SUBJECT: ST. LUCIE UNIT 2 - ISSUANCE OF AMENDMENT RE: PRESSURE/TEMPERATURE LIMITS AND LOW TEMPERATURE OVERPRESSURE PROTECTION (TAC NO. 66709)

Amendment No. 31  
License No. NPF-16

ATTACHMENT TO LICENSE AMENDMENT NO. 31  
TO FACILITY OPERATING LICENSE NO. NPF-16  
DOCKET NO. 50-389

FIGURE 3.4-2  
 ST. LUCIE-2 P/T LIMITS, 6 EPY  
 HEATUP AND CORE CRITICAL

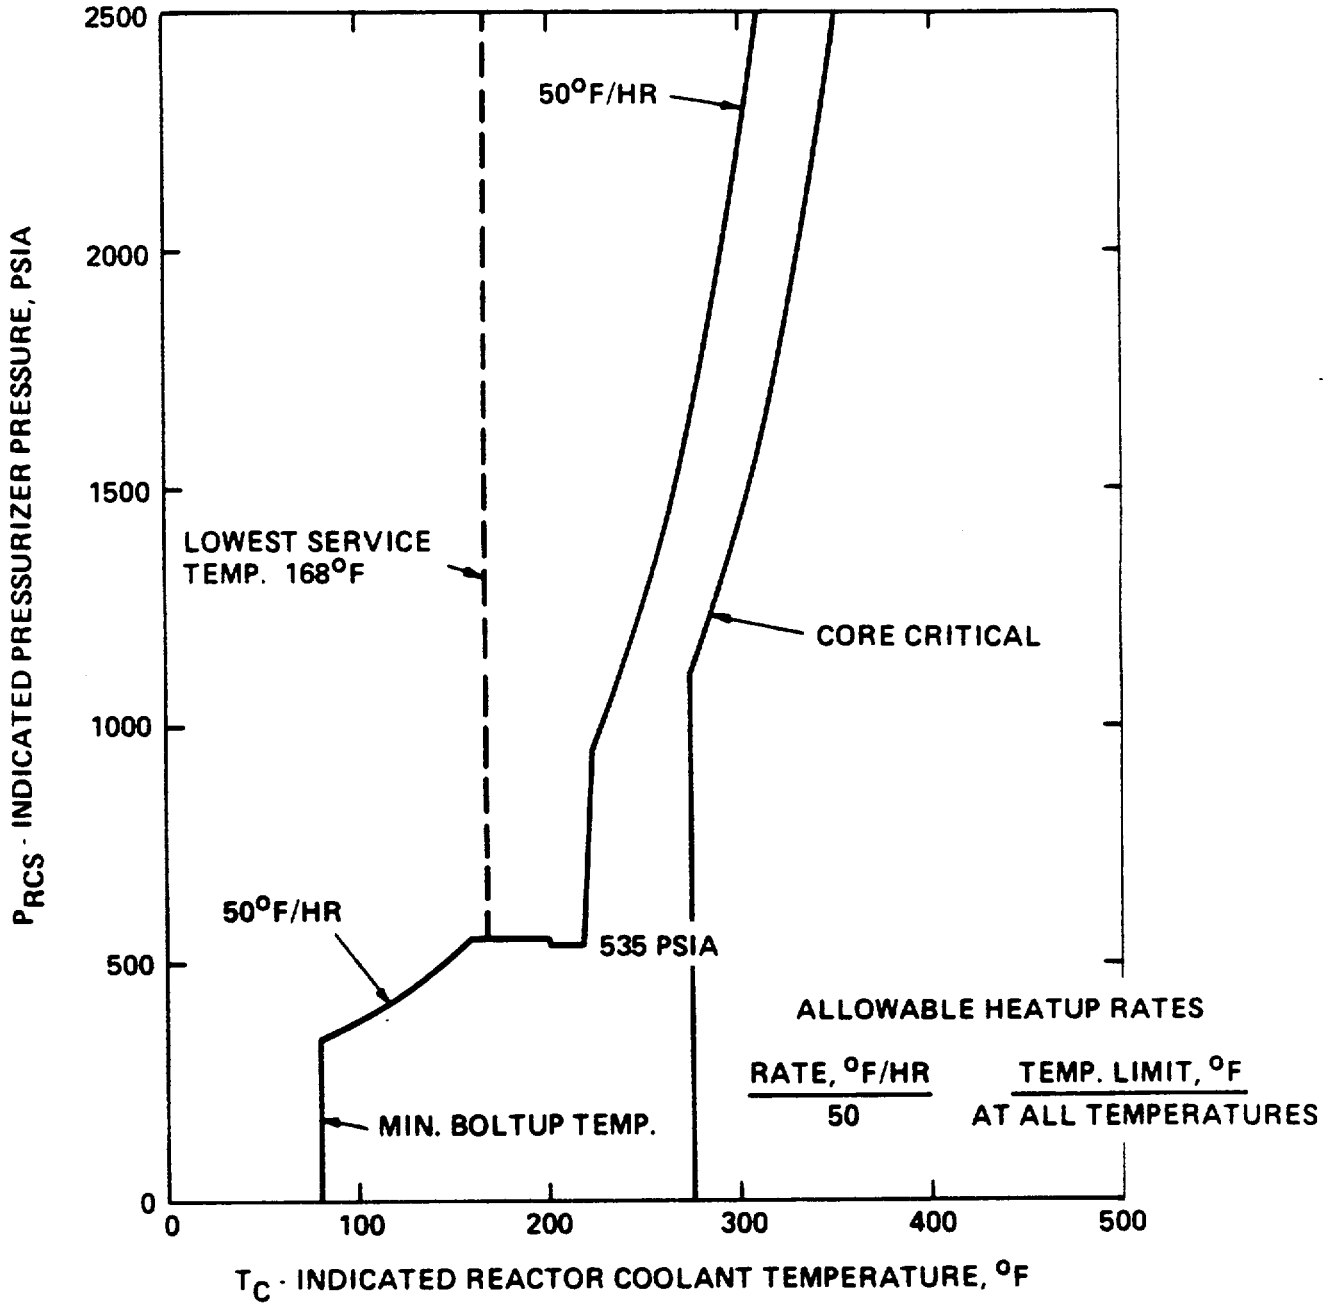
This amendment changes the Reactor Coolant System Pressure/Temperature (P/T) limit figures to be effective up to six (6.0) effective full power years of operation. The amendment also changes the Technical Specifications dealing with overpressure protection systems because they are linked with the new P/T limit figures. The applicable bases sections are also changed to reflect the above changes.

The intersection between the control pressure 535 psia and the 50 degrees per hour heatup curve in Figure 3.4-2 gives the minimum temperature at which the LTOP function can be transferred from the SDCRVs to the PORVs during heatup, 156 degrees F, and the intersection between 535 psia and the 100 degrees per hour. cooldown curve in Figure 3.4-3 gives the minimum temperature at which the LTOP function must be transferred from the PORVs to the SDCRVs during cooldown, 179 degrees F. The temperatures at which cooldown rates must be reduced are determined by the control pressure 345 psia. These cooldown rates versus coolant temperature are plotted in Figure 3.4-4. The intersections between the safety valve setpoint of 2500 psia and the 50 degree per hour heatup curve and the 100 degree per hour cooldown curve define the maximum LTOP temperatures for heatup, 313 degrees F, and for cooldown, 304 degrees F; these temperatures are taken as upper bounds for the regions in which LTOP is required. The staff finds these limiting temperatures, shown in Tables 3.4-3 and 3.4-4, acceptable to only 6 EFPY for the reasons discussed in the previous section of this report.

FIGURE 3.4-3  
 ST. LUCIE-2 P/T LIMITS, 6 EPY  
 COOLDOWN AND INSERVICE TEST

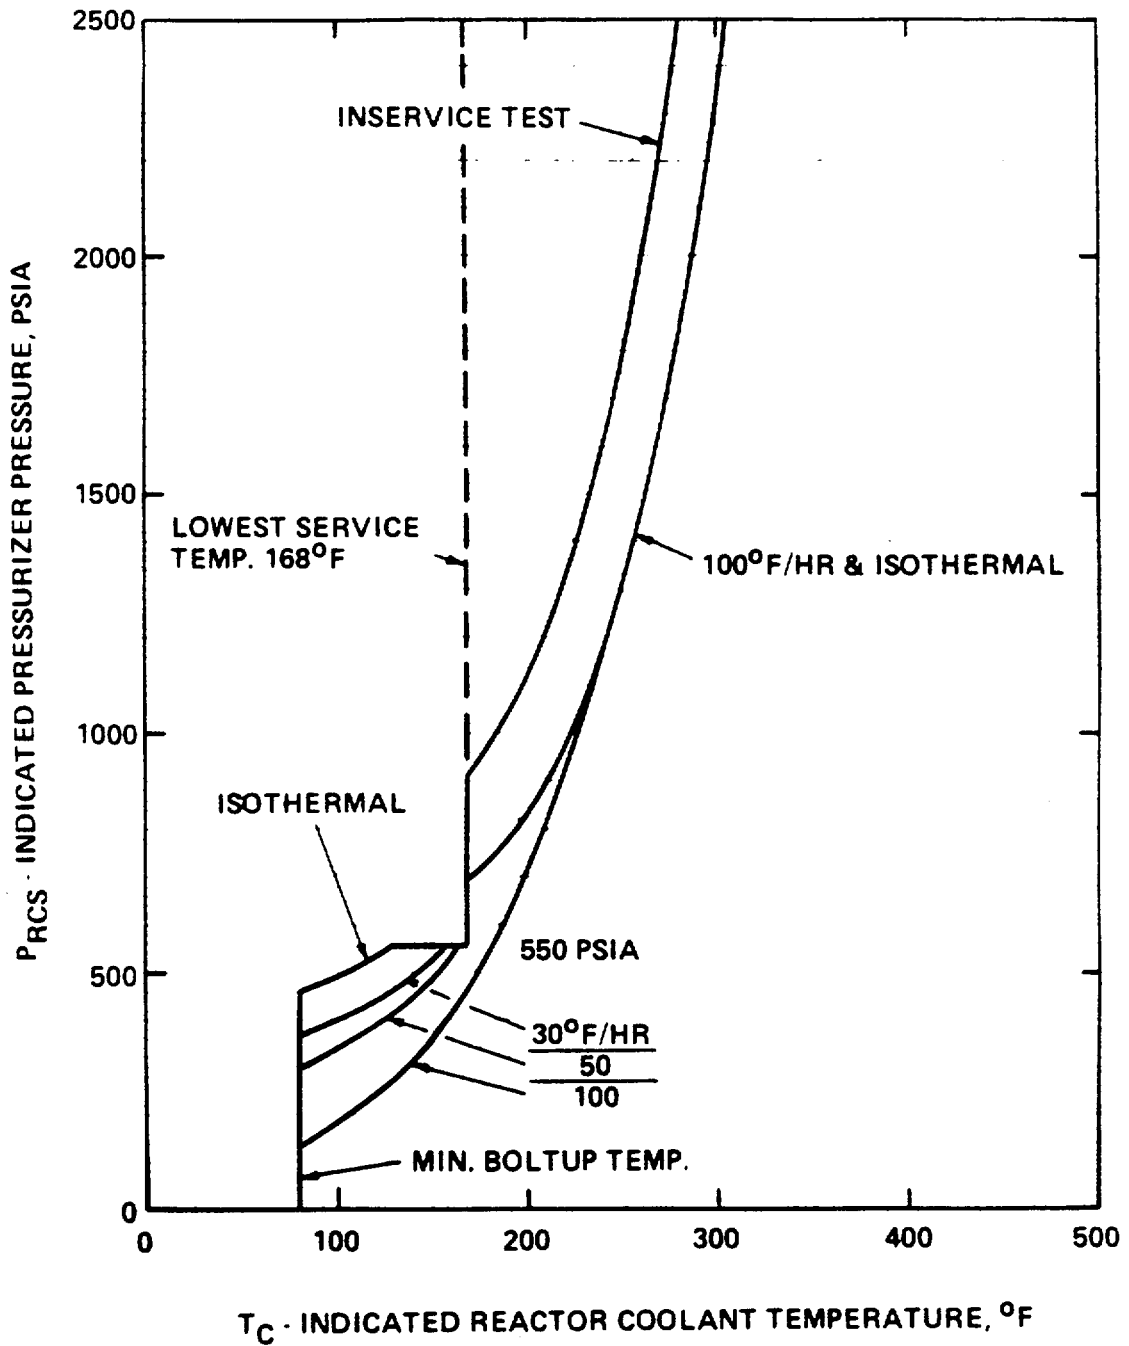
For inservice hydrostatic testing, the postulated flaw at  $1/4t$  is controlling and the P/T limits curve calculated by the staff is essentially the same as that calculated by the licensee, as shown in Figure 3.4-3, and the resulting minimum criticality temperature of 270 degrees F is acceptable to the staff. Similarly, for cooldown, the postulated flaw at  $1/4t$  is controlling. The cooldown curve for 100 degrees F per hour computed by the licensee conservatively bounds the corresponding P/T limits curve computed by the staff. Also, the cooldown curves for 0 (isothermal), 30, and 50 degrees F per hour, all shown in Figure 3.4-3, are conservative and acceptable to the staff.

FIGURE 3.4-4  
 ST. LUCIE-2 P/T LIMITS, 6 EFPY  
 MAXIMUM ALLOWABLE COOLDOWN RATES

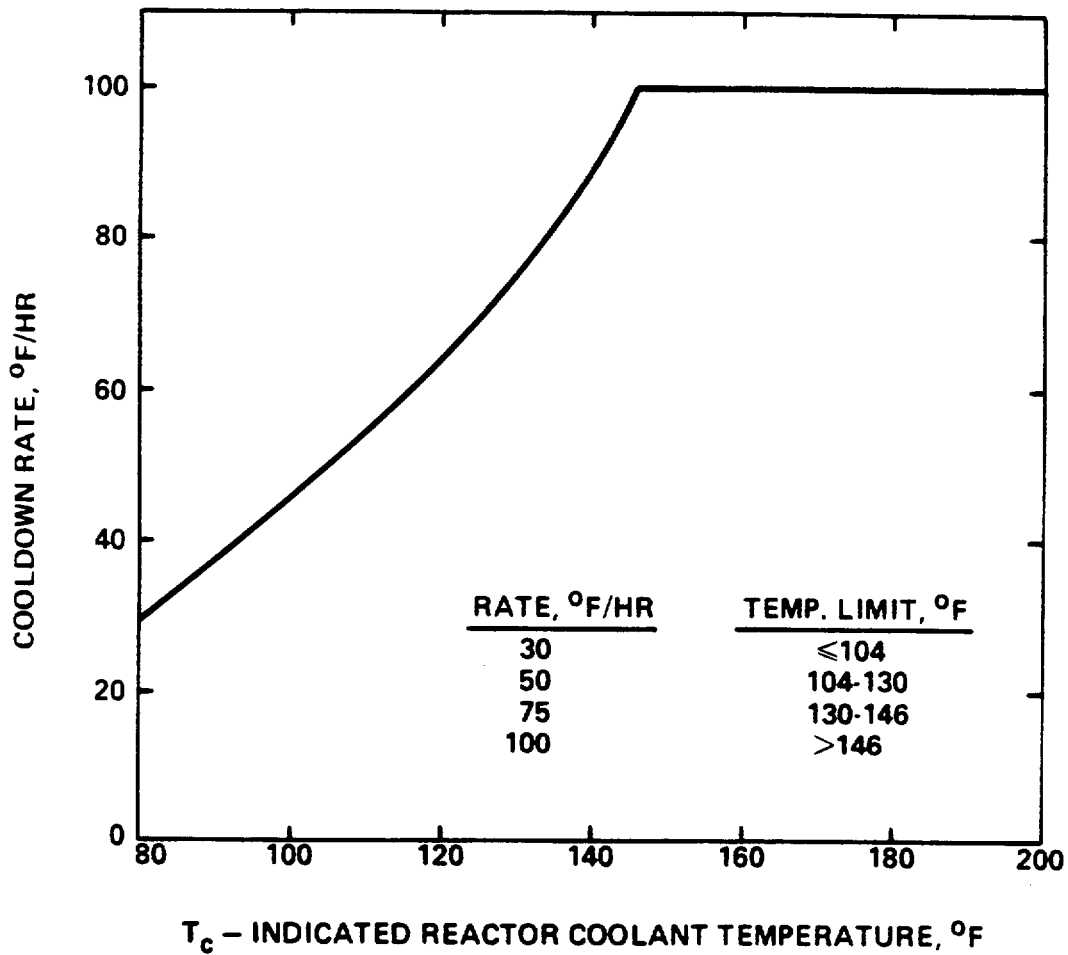
The licensee proposes to add Figure 3.4-4 showing the maximum allowable cooldown rate versus reactor coolant temperature. Following this curve keeps the reactor coolant pressure above 345 psia until the minimum boltup temperature is reached. The 345 psia is an LTOP controlling pressure which will be discussed further in the next section of this report. This addition is acceptable to the staff.

NOTE: A MAXIMUM COOLDOWN RATE OF  
 100°F/HR IS ALLOWED AT ANY  
 TEMPERATURE ABOVE 146°F

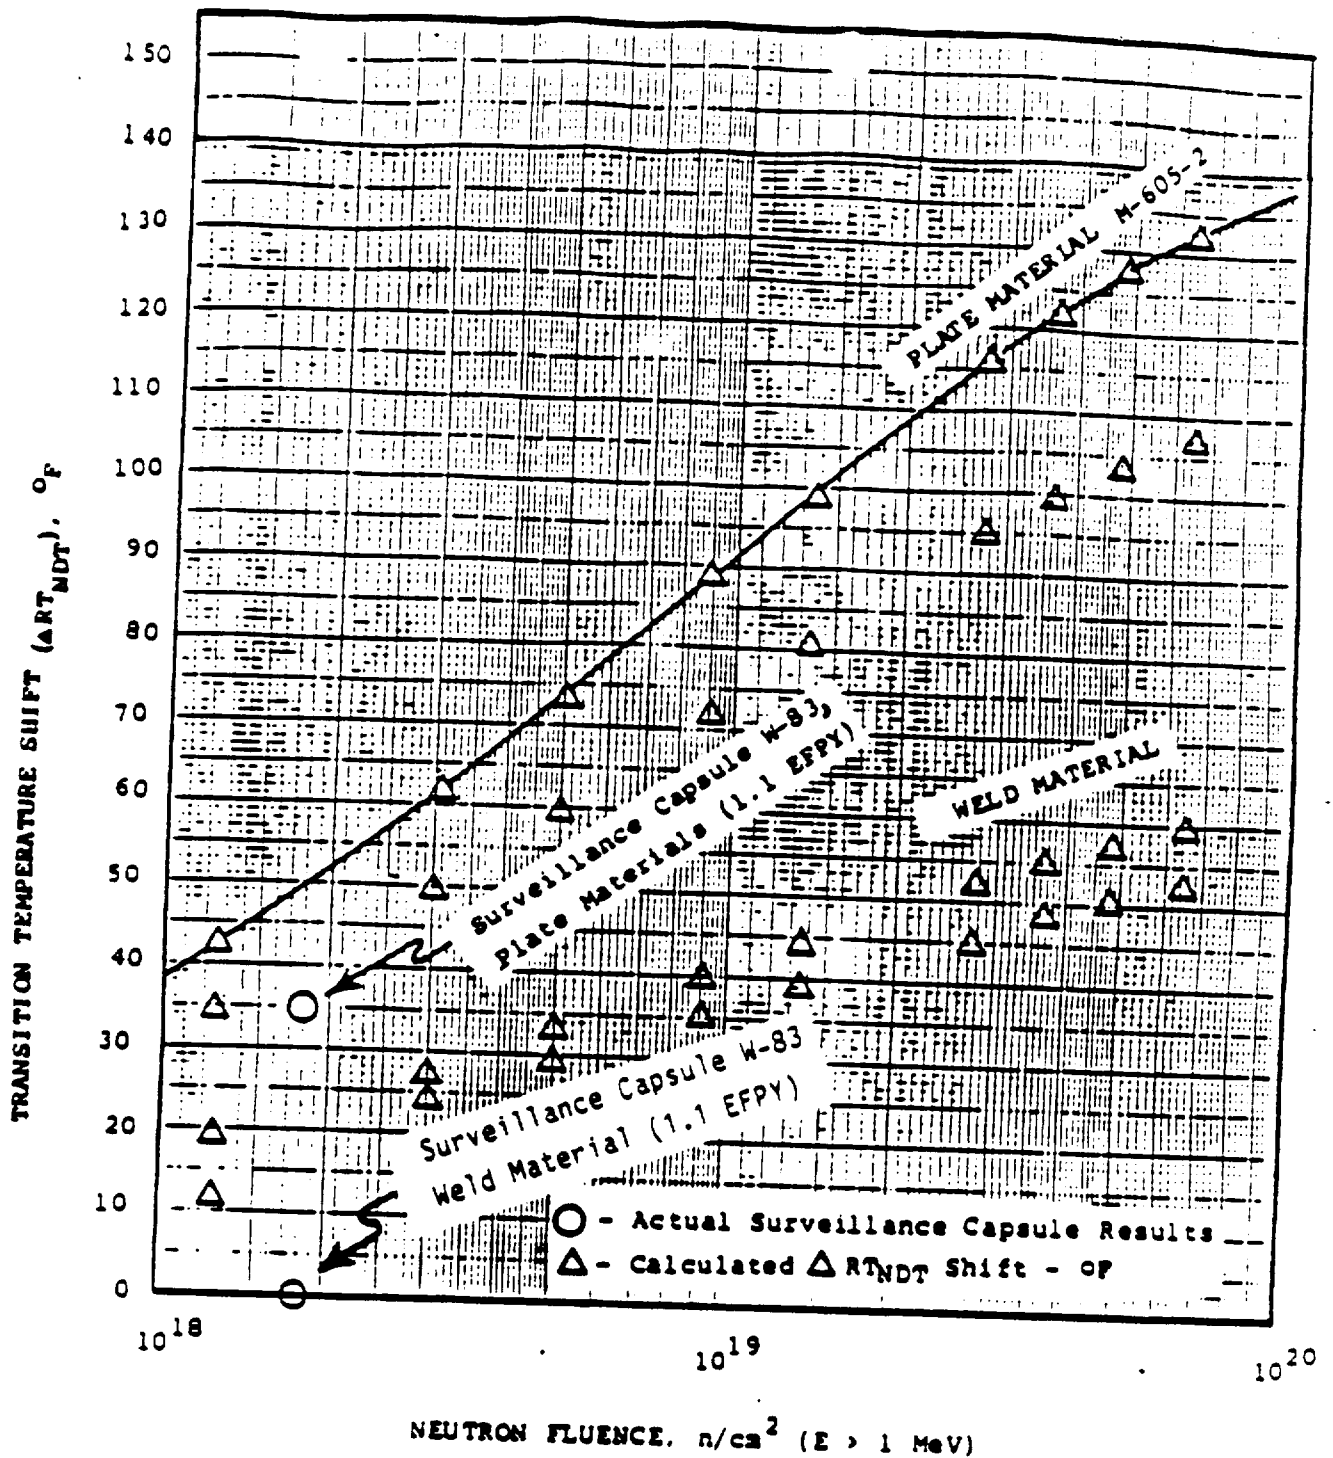
The licensee also proposes to change Table 4.4-5, Reactor Vessel Material Surveillance Program - Withdrawal Schedule, increasing the lead factor from 1.15 to  $\leq 1.5$ , and Table B 3/4.4-1, Reactor Vessel Toughness, correcting errors in the columns Drop Weight Results and Temperature of Charpy V-Notch RT<sub>NDT</sub> (degrees F) @ 50 ft-lb. These changes are acceptable to the staff.
